IREDELL COUNTY HEALTH DEPARTMENT

IMPROVEMENT PERMIT / AUTHORIZATION TO CONSTRUCT / OPERATION PERMIT / EXISTING SYSTEM

APPLICANT: Mark Benitez APPLICANT ADDRESS: 118 Surfside Drive Mooresville, NC 28117

SUBDIVISION: Commodore Peninsula SECTION: LOT # 95 LOT AREA: 0.359 acres DESIGN FLOW: 480 GPD L.T.A.R.: 0.30

AS BUILT SKETCH

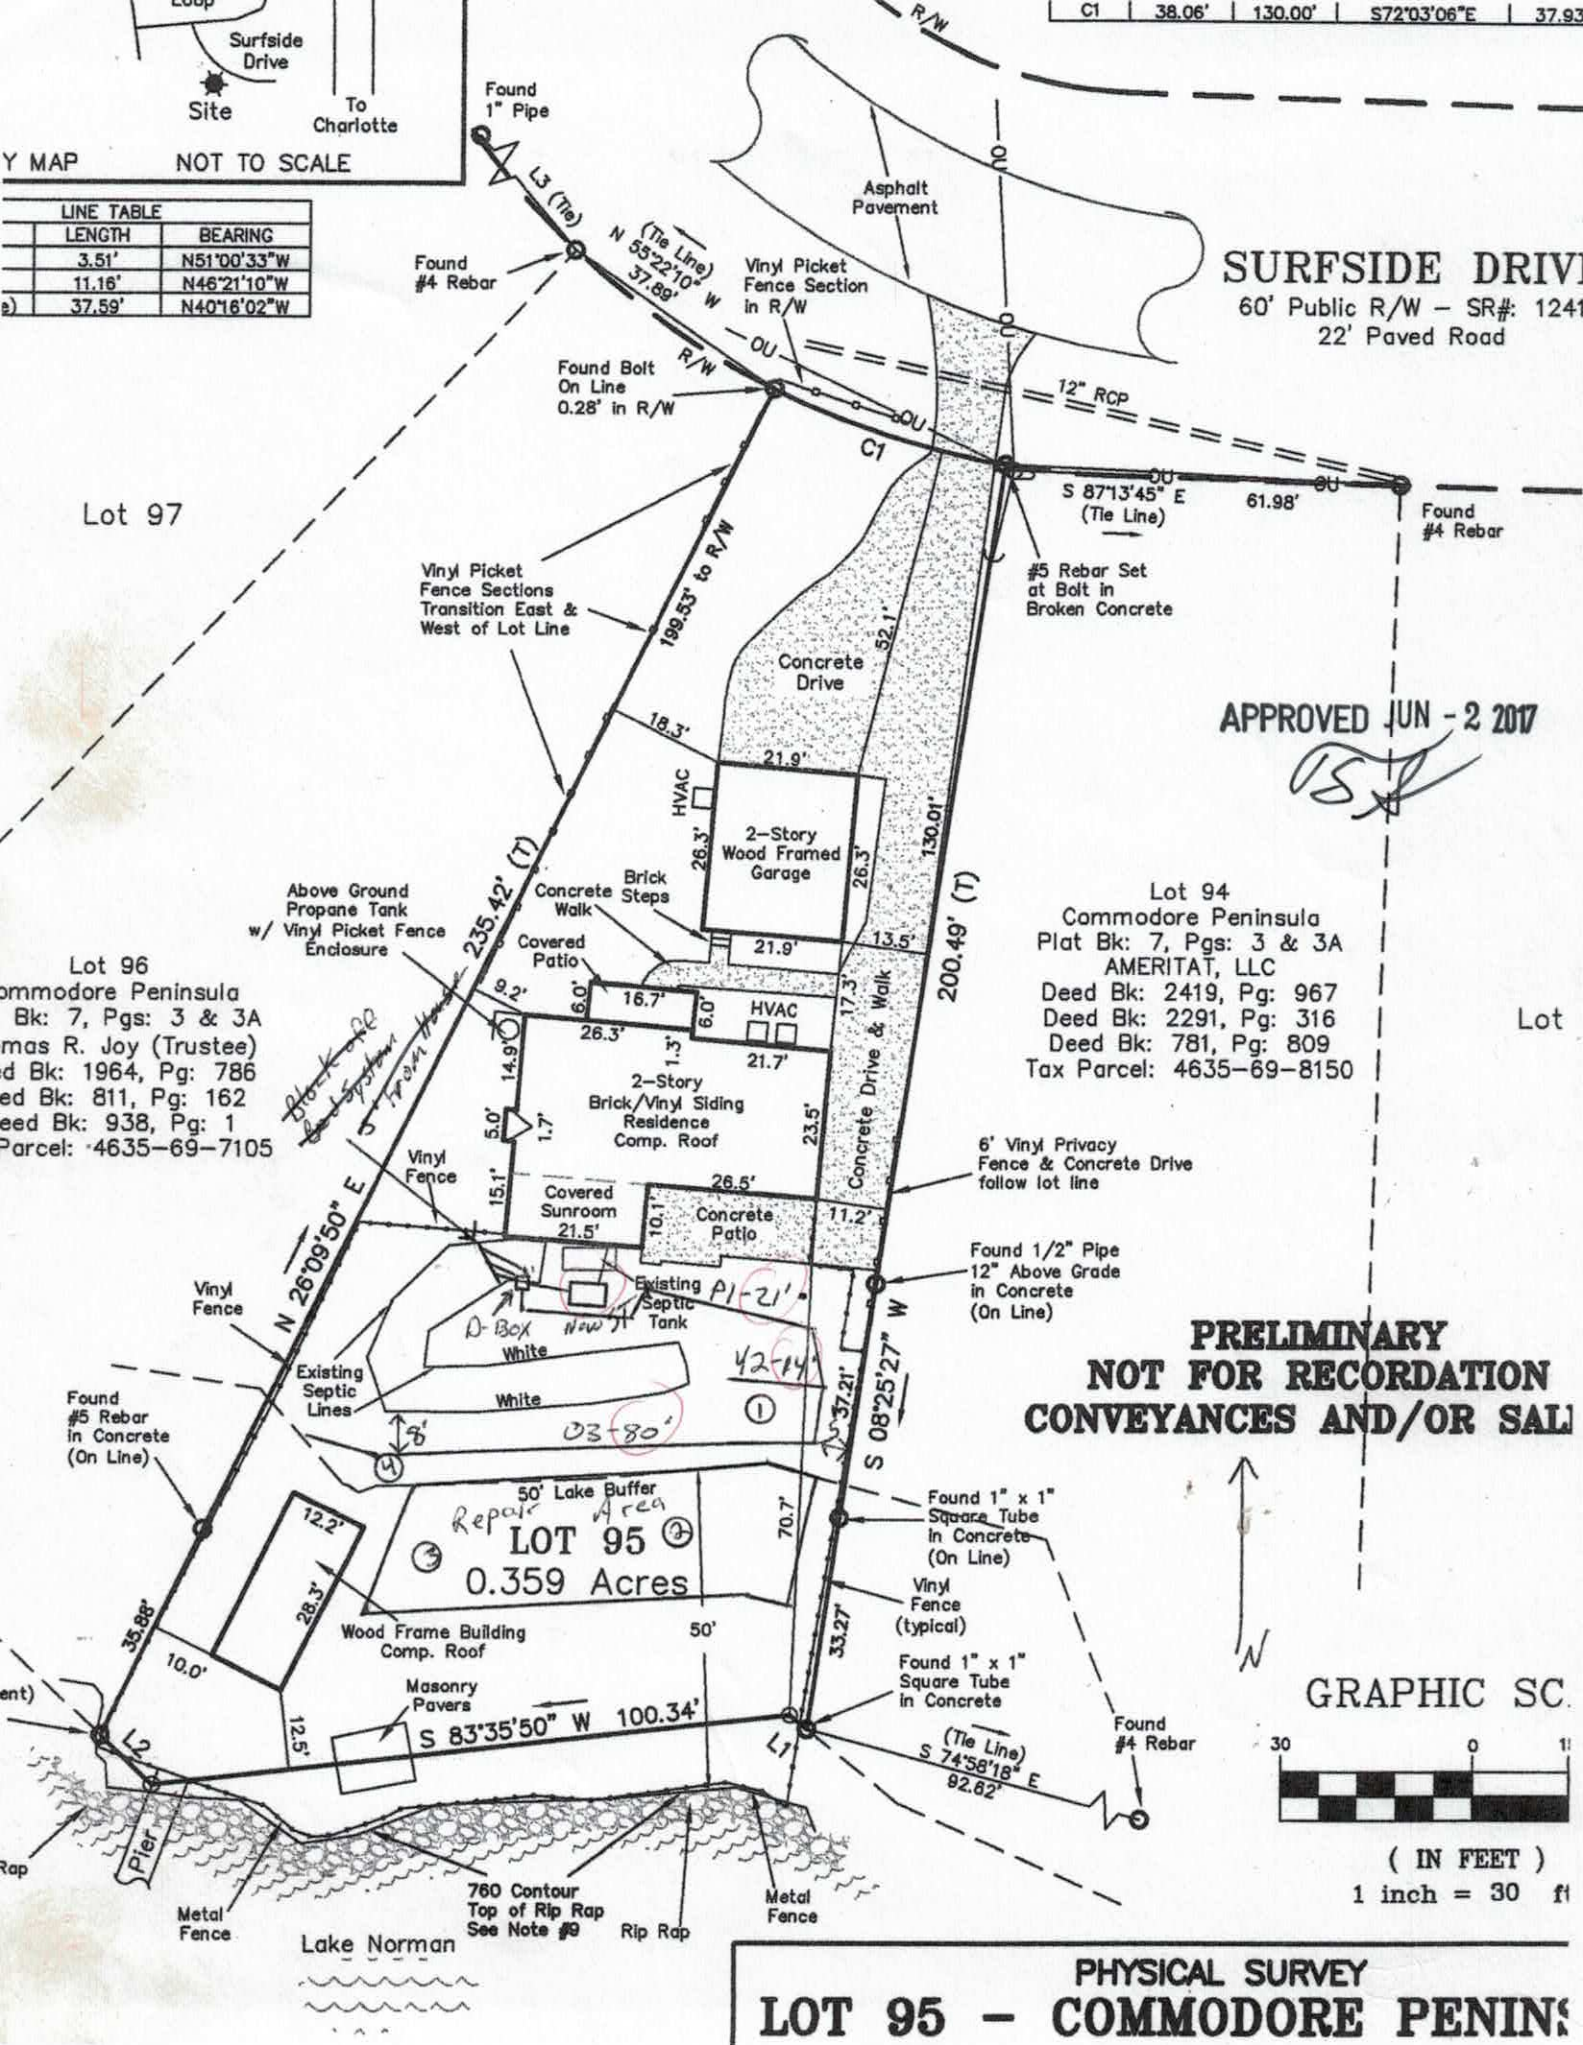
Comments / Conditions: Old septic tank shall be pumped, limed and either 1) Crushed in place 2) hauled away or 3) Filled with clean, flowable fill that is essentially self leveling (gravel, sand or cement) New septic tank must be at least 5 feet from house.

DO NOT DISTURB existing bed system that is already encroached by porch slab. Set distribution box to act as drop box to serve "new" lines after existing septic bed has been used. Recommend pumping septic tank every 3-5 years.

★ Per applicant, existing house dimensions shall not be changed from the existing layout ★

Quick 4 Chambers
Polylock filter present.
Plastic tank.
